TREVOR R HOWSE

DESIGN SPECIFICATION

ACCESSIBILITY

Harbord Beach Hotel

Figure 2.1.1 – proposed ground floor plan

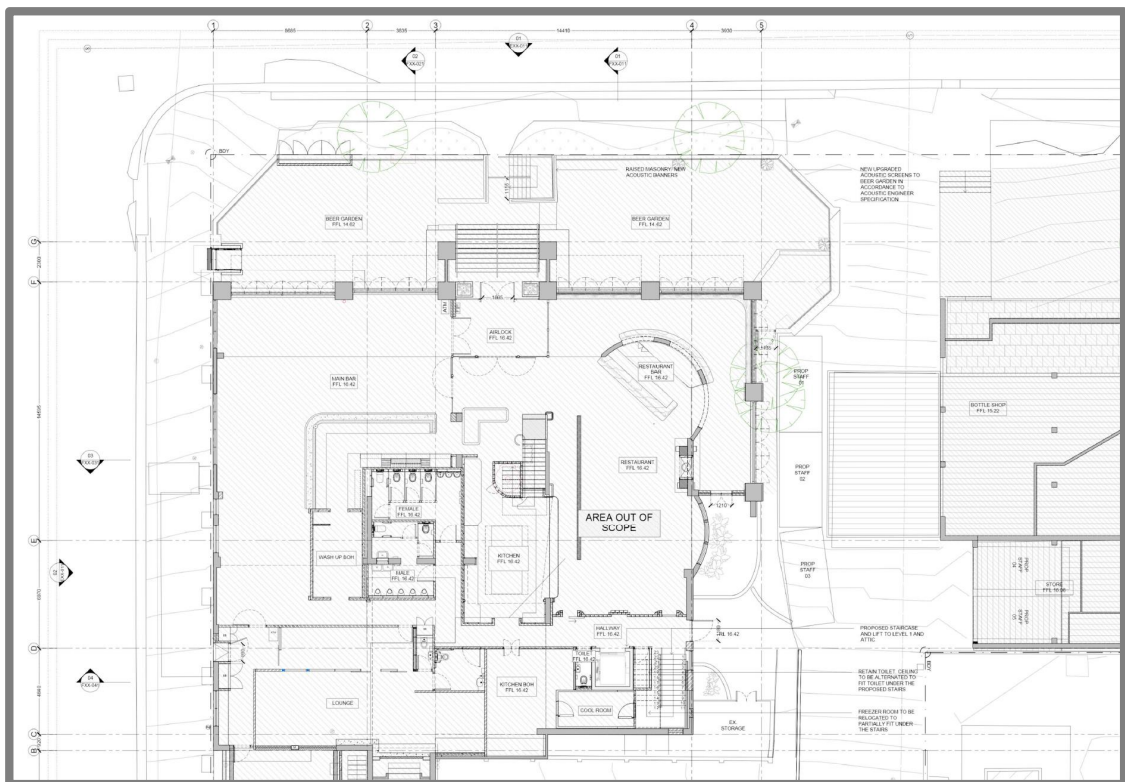
Particular attention is drawn to the base of the proposed stairway in the ground floor, as the handrails must extend one step + 300-mm (minimum 550-mm), and the new small stairway in the upper floor.

- (a) The base of the new stairway in the ground floor;
- (b) The first floor where the ascending stairway discharges into the floor.

Figure 2.1.2 – proposed first floor plan

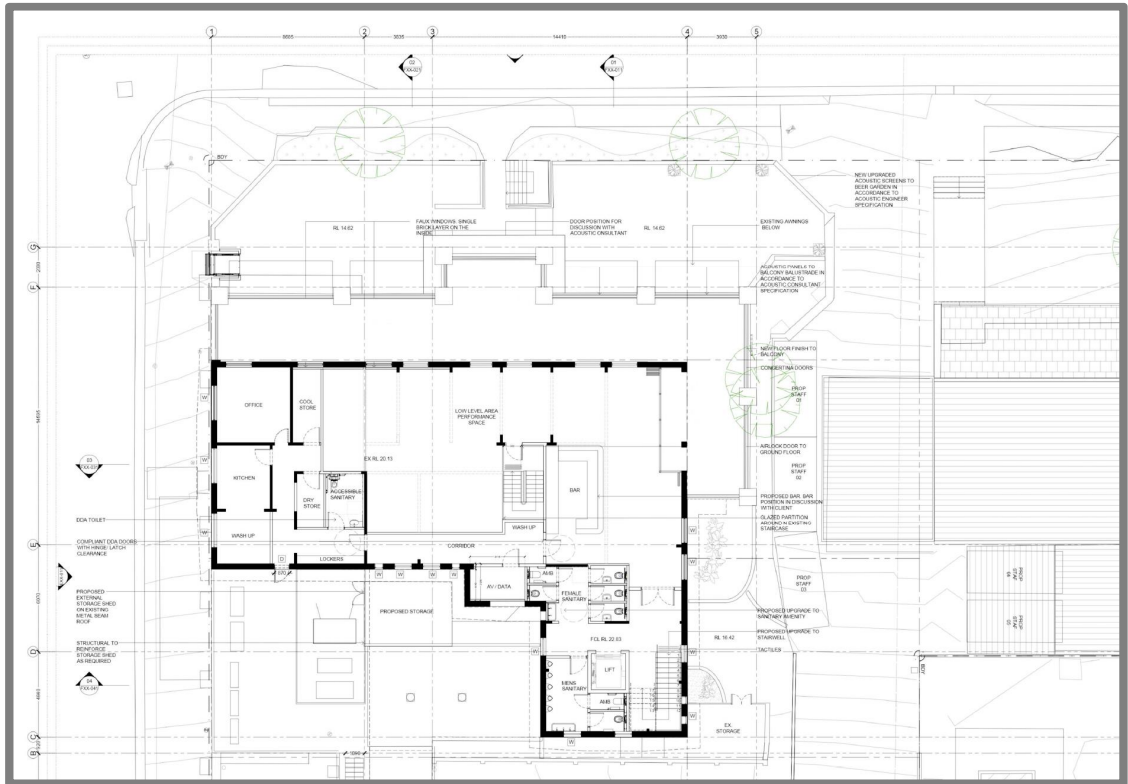
- (b) Existing office, first floor . the doorway opening is not provided with AS 1428.1 compliant circulation space to the latch side of the door leaf, on the corridor side of the doorway opening (510-mm required).

- (c) Lockers, first floor . the position of the lockers appears to encroach on the 530-mm clear circulation space required to the latch side of the door leaf to the corridor, on the toilet side of the doorway opening.

- (d) Doorway to corridor, first floor . the doorway opening adjacent to the bar and providing access from the public space to the corridor leading to the accessible toilet need be provided with AS 1428.1 circulation space to the latch side of the door leaf, on both sides of the doorway opening (510-mm on corridor side, and 530-mm on public side).

Figure 2.1.3 – proposed upper floor plan

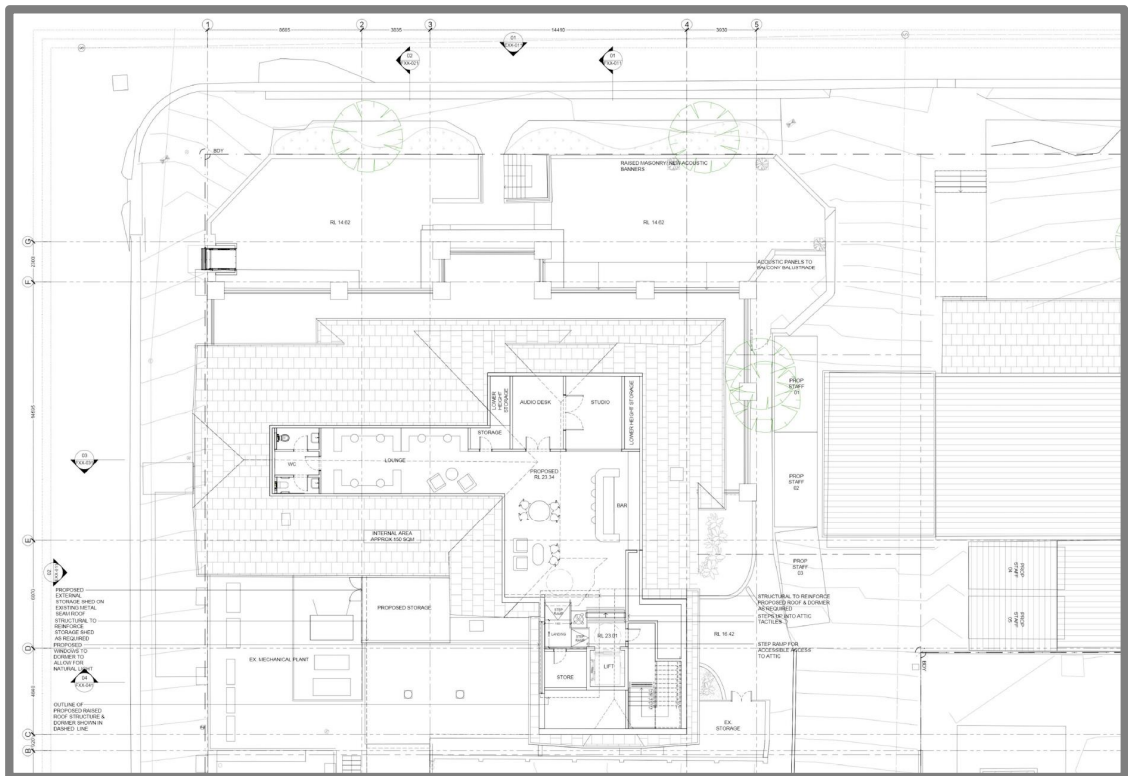
- The proposed design includes the provision of sanitary facilities in the upper floor, but does NOT include an accessible facility (**NB:** this provision of NCC 2019 requires the provision of an accessible toilet on each level provided with sanitary facilities).

This design approach will necessitate the preparation of a performance solution report at the Construction Certificate stage of the approvals process.
